Bell Quarry Rehabilitation Project
Additional response to submissions – DA294/18

BELL QUARRY REHABILITATION PROJECT

PROJECT ITEMS OUTSIDE SITE BOUNDARY

Figure 1 IESC (2019) decision tree for the derivation of SSGVs for physico-chemical stressors and toxicants

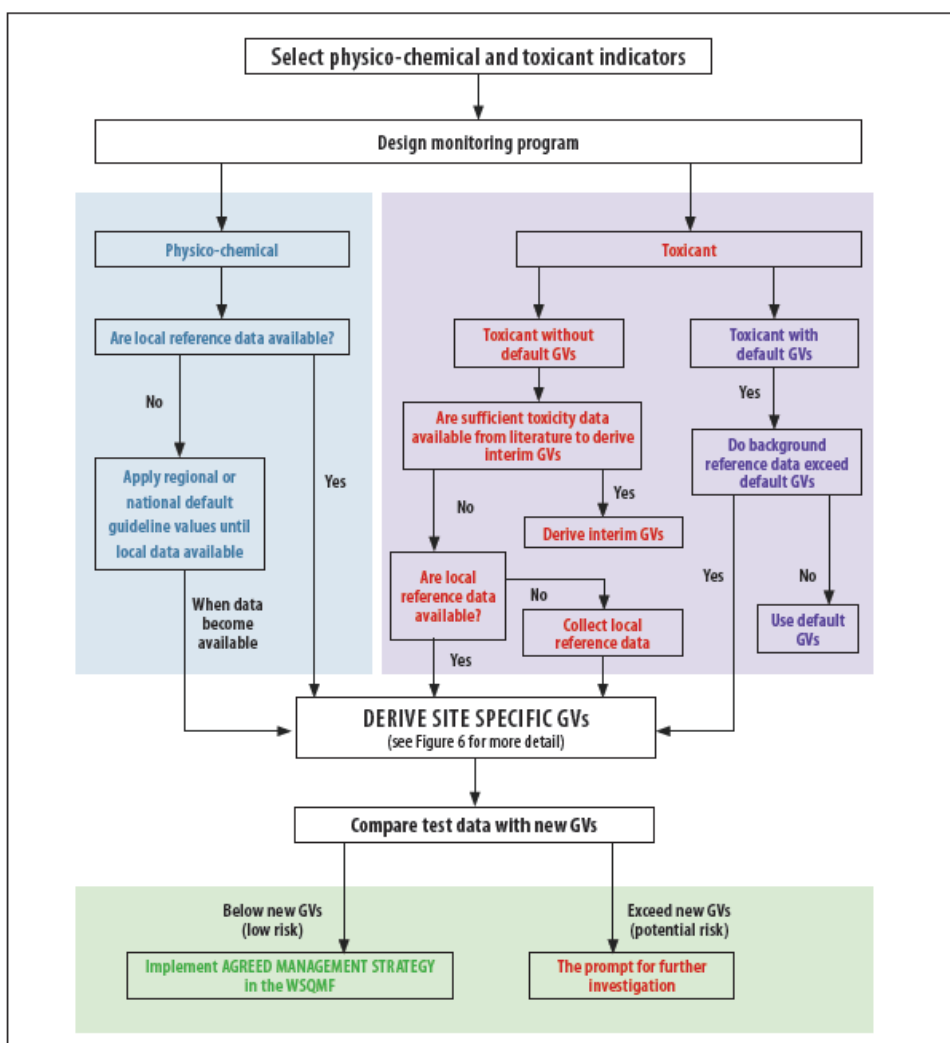
Point 7 in Council's request for clarification highlighted EPA and OEH concerns regarding the potential for impact of discharges to receiving waters in the Wollongambe Catchment and the Greater Blue Mountains World Heritage Area. Specific queries were in relation to the lack of baseline environmental sampling and derivation of site specific guideline values for physico-chemical parameters and toxicants in accordance with IESC, 2019.

IESC (2019) provides a decision tree for physio-chemical and toxicant indicators, which has been reproduced as Figure 1 below. Following the methodology provided, the 'use default GVs' option is the most appropriate and recommended outcome for toxicants, and for physico-chemical stressors the application of DGVs is recommended until local data become available. As such, the methodology used in the EIS is appropriate for managing the risk of water pollution to the Wollangambe River catchment and World Heritage Area, and is in line with the SEARs.

approved (PD) SK001

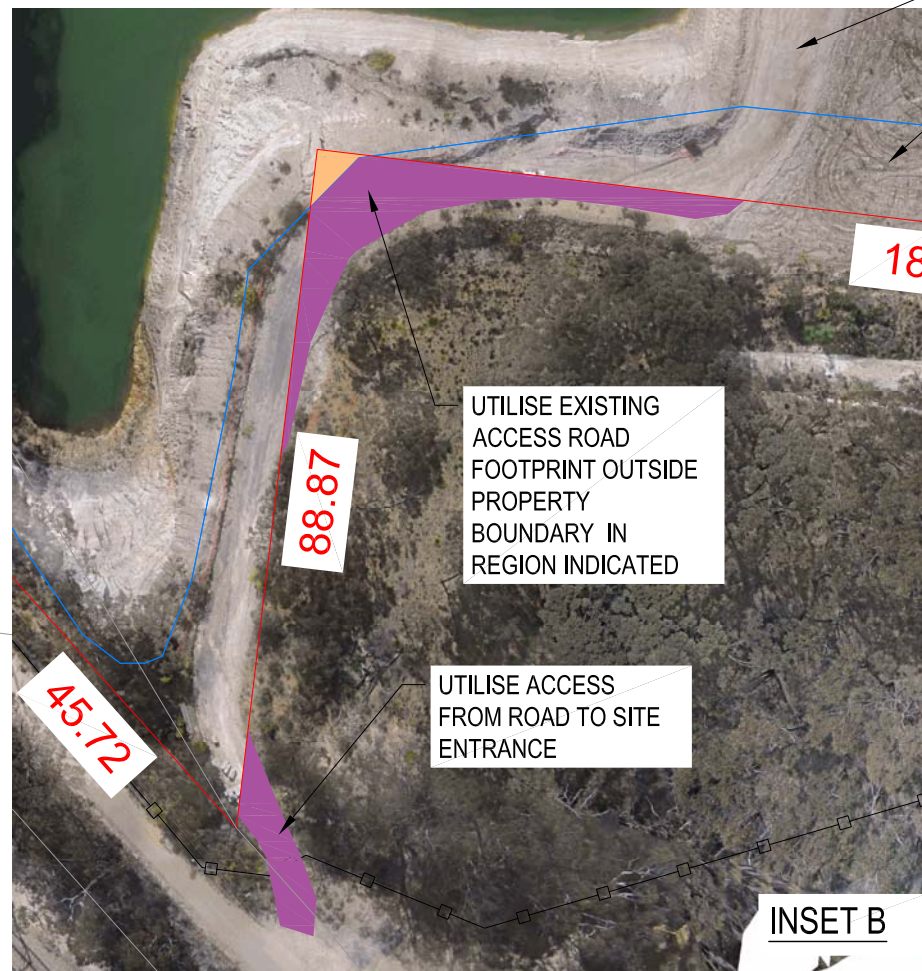
Points 1 to 3 in Council's letter seeks clarification in relation to inconsistencies relating to the existing quarry footprint in relation to the detailed boundary survey undertaken at the site during preparation of the Environmental Impact Statement (EIS).

The boundary survey was undertaken following a site meeting with Council and National Parks and Wildlife (NPWS) representatives following discussions regarding boundary irregularities in the locality. The survey demonstrated that disturbance footprint of the previous extractive operations has extended beyond the surveyed site boundary at two locations. The edge of the main quarry void along the western boundary extends as a thin strip of approximately two metres onto Crown Land. The haul road into the site also bisects a small portion of land within the NPWS estate at the entrance to the site and a portion of the existing sediment basin is located outside the site boundary as shown in the updated plans in Attachment 1.

Rehabilitation at the site will be undertaken entirely within the existing disturbance footprint of the quarry. It will be necessary to fill marginally beyond the surveyed boundary of the site to encompass the entire disturbance area to provide effective stability and stormwater management for the final landform. Filling to the extent of the near vertical existing batters will be required to prevent pooling and uncontrolled discharge of stormwater from the site and the rehabilitation strategy is consistent with the requirement to undertake rehabilitation within a 20 metre strip of the adjoining Blue Mountains National Park within the existing consent.

There are no physical rehabilitation works proposed to be undertaken within the existing sediment basin outside the eastern boundary of the site. The proposed water management system does not rely upon the use of the sediment basin to achieve the performance objectives for the project and therefore the sediment basin is not considered to be included as part of the development application for the purpose of land owners consent. Liaison with NPWS would be maintained for the purpose of monitoring the quality of water and control of ongoing discharges from the site.
